48-23-01 - Travel Assist Currently Not Available

Release date: 4/16/2024

Figure 2.

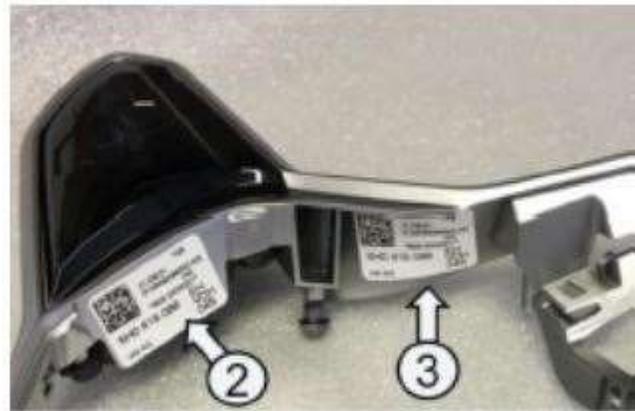
- Remove the steering wheel according to the repair manual. See Repair Group 48 in Elsa.
- Remove multifunction button set and transfer to new steering wheel according to the repair manual.
- The new steering wheel will have the supplied label/sticker (see figure 1) that will need to be applied to the trim panel on multifunction button set, (see figure 2).

The old label (see Figure 2) must not be covered up.

Position of old (2) new (3) label on trim panel.
